1st Review

Comments in magenta red provided by Chris Hill, chhill@auroragov.org (Drainage)

**PORTEOS PA-11 MIDDLE
DIA PRE-FLIGHT PARKING FACILITY**
NWC OF N JACKSON GAP W & E 56TH AVE, AURORA, CO 80019

PRELIMINARY DRAINAGE PLAN

PDP1.1

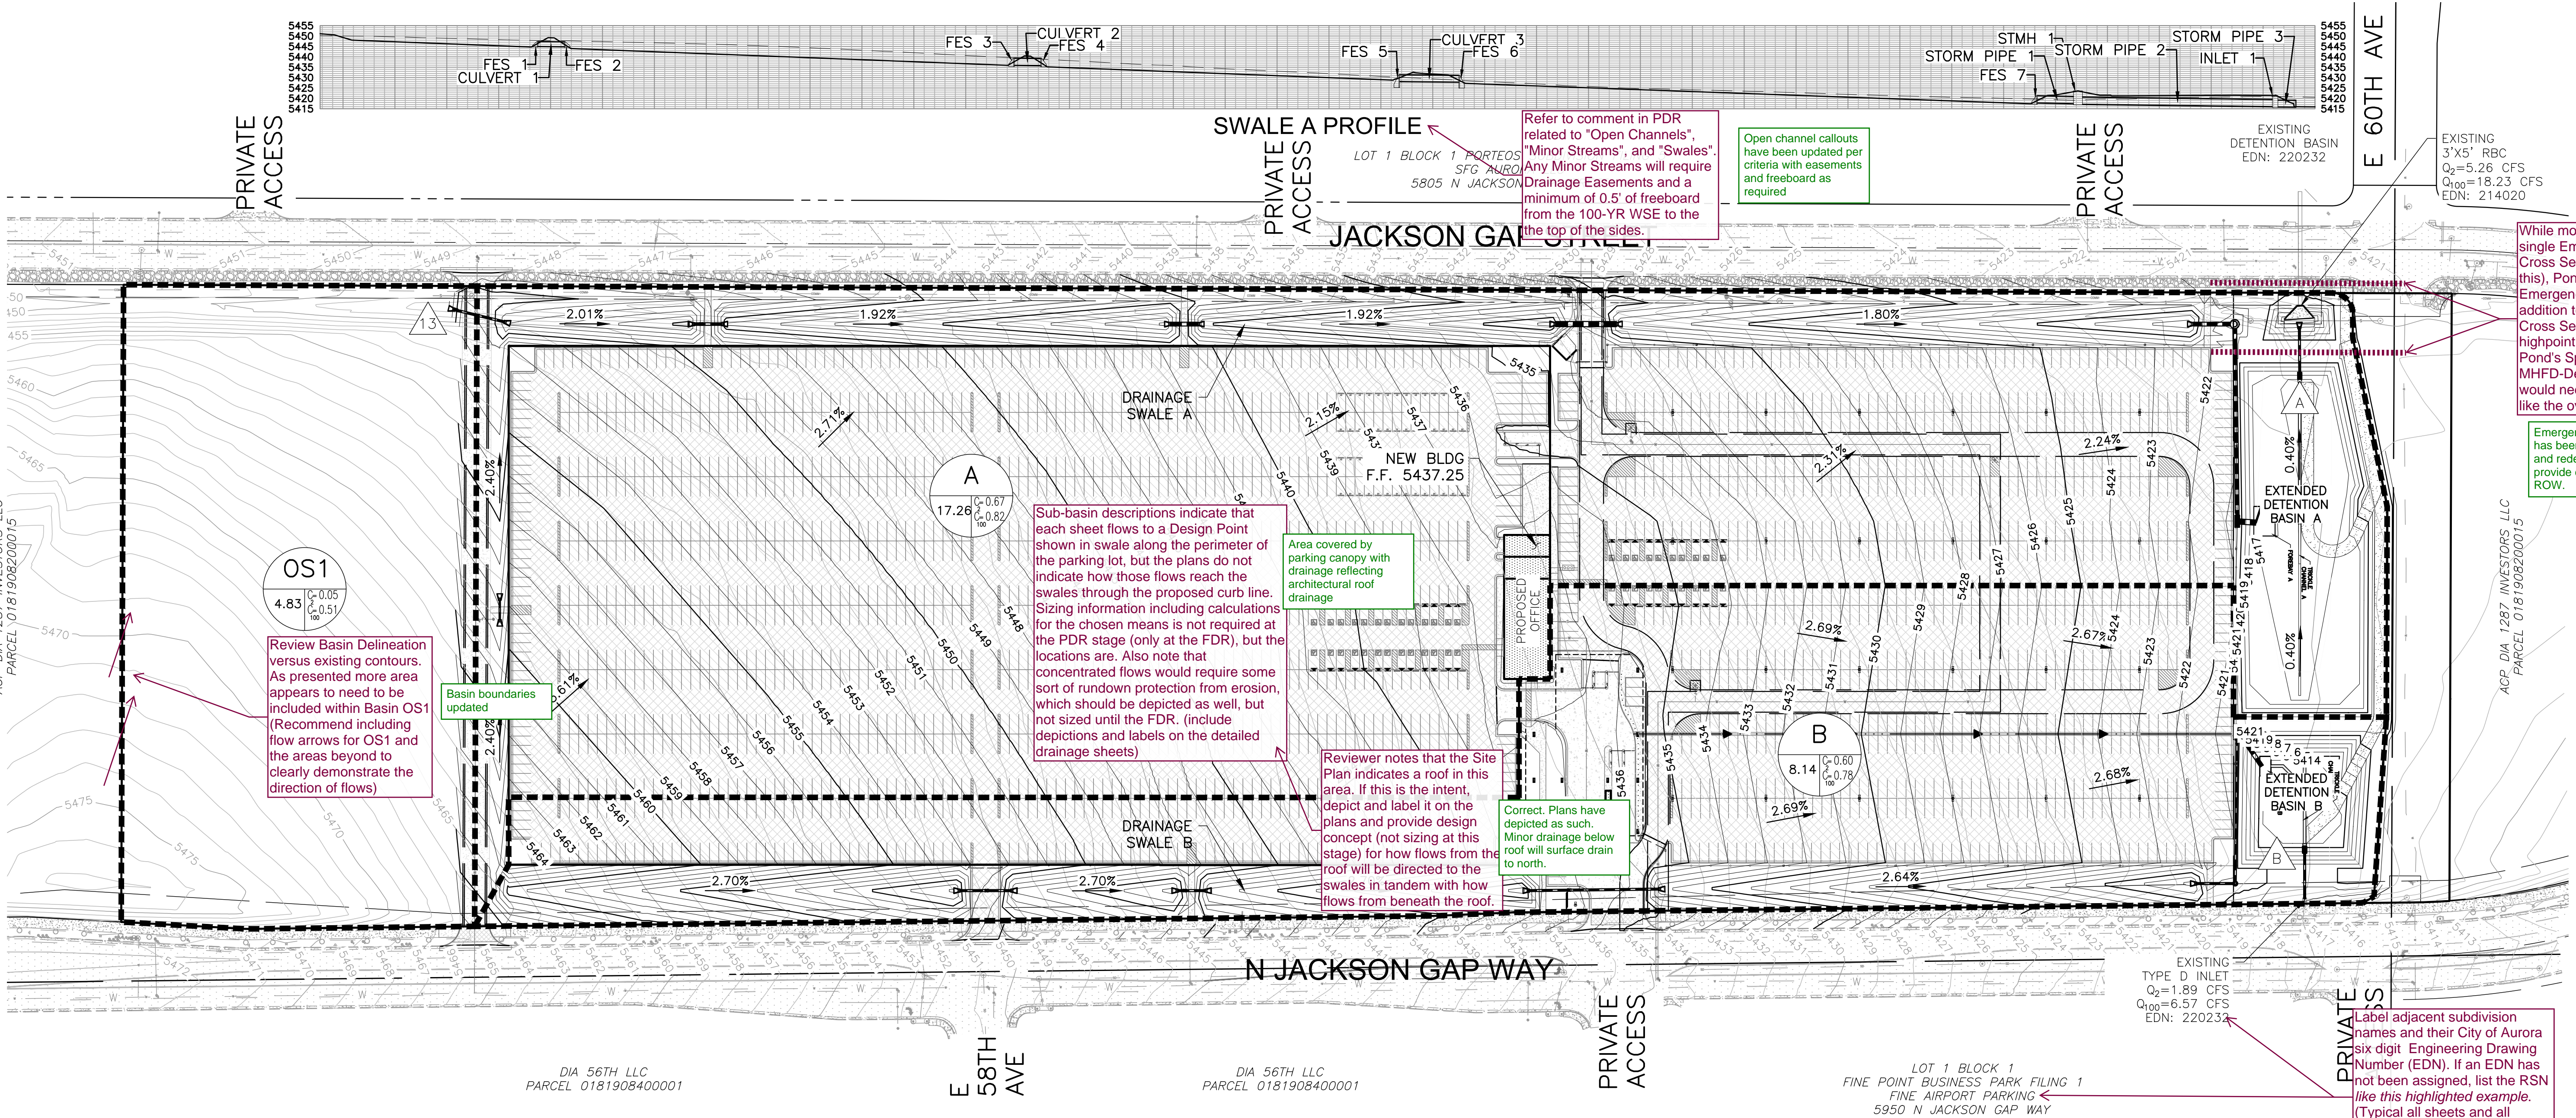
Revise Benchmark to match Benchmark description on the City's website (Typical):

For the Preliminary Drainage Report and Plans as well as the eventual Final Drainage Report and Civil Plans, refer to the project's full subdivision name: "Porteos Subdivision Filing #10". The PA-11 Middle Subdivision can be included as a second line. Note that this does not apply to the Site Plan submittal. (Typical all Title Blocks)

Revise Tables as necessary after addressing comments in report (typical all sheets, comment appears once)

Benchmark information updated

Revisions removed from PDP

All tables revised and updated

PDP1.2

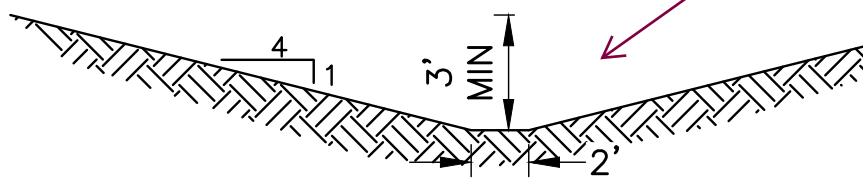
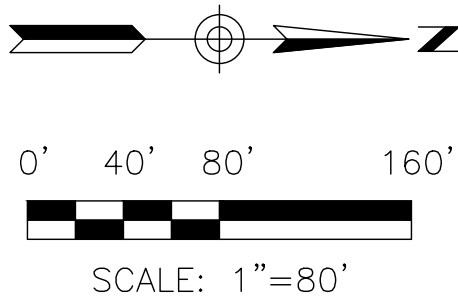
While most Extended Detention Basins require a single Emergency Overflow Calculation and Cross Section (Pond B below is an example of this), Pond A has two locations where Emergency Overflows could be passed. In addition to the Emergency Spillway Overflow Cross Section, include a second one for the highpoint in Jackson Gap Street. (Note that the Pond's Spillway WSE can be calculated by the MHFD-Detention Spreadsheet, but the Road would need to be analyzed as an irregular weir like the overflows for the proposed culverts.

Label adjacent subdivision names and their City of Aurora six digit Engineering Drawing Number (EDN). If an EDN has not been assigned, list the RSN like this highlighted example. (Typical all sheets and all adjacent projects and properties. Comment appears once.) (SDDTC 2.3.5, 2.4.4, 2.5.3.1)

For each emergency overflow location, include a cross section with the emergency overflow discharge, WSEL, dimensioned freeboard, and adjacent building lowest point of entry (LPE) if applicable.

(SDDTC 2.2.4.U)

Emergency overflow has been evaluated and redesigned to provide conveyance to ROW.

Labels updated to include EDN where available

Emergency overflow cross sections added

PDP2.3

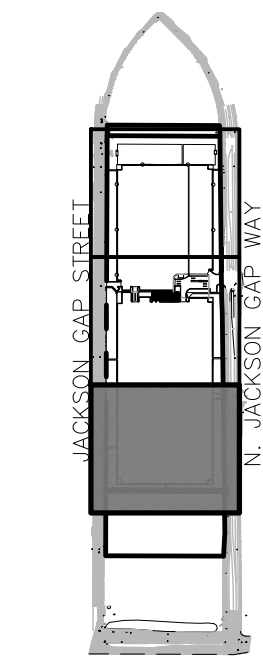
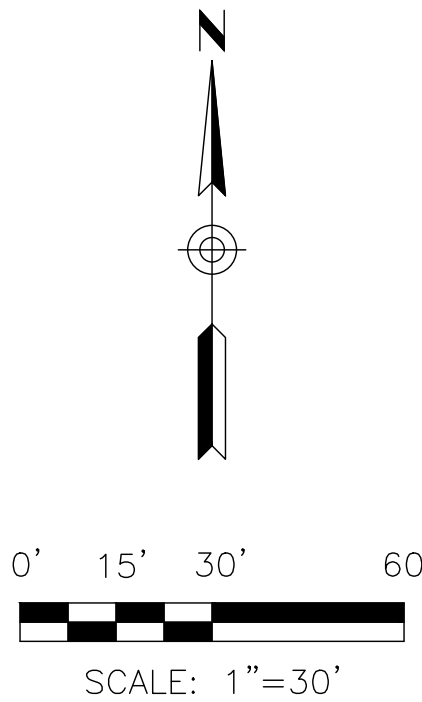
"For each pond, label the WQCV, EURV, and 100-year storage volumes and WSELs. Note the allowable release rates, maximum depths, ponding limits, and any other water quality SCM data as needed for the proposed SCM. Label pond side slopes, bottom slopes, trickle channel slopes, etc. as applicable. Label maintenance access, material, and turn radius as applicable." (SDDTC 2.2.4.7)

Maintenance Access to Detention Ponds is not allowed from Collectors and should be provided from within the Site. (Typical both proposed ponds)

Show and label Drainage Easements on Plans. Note that the Drainage Easement for the proposed EDBs will need to encompass any external slopes as well (Typical all sheets, comment appears once)

Provide vehicle access to forebay, top of outlet structure, and to spillway as well (refer to SDDTC section 10.7)

Label classifications of surrounding/adjacent roads (Typical)

Easements shown and labeled

Access modified and rollover curb will provide access across pond

Street classifications added throughout plans
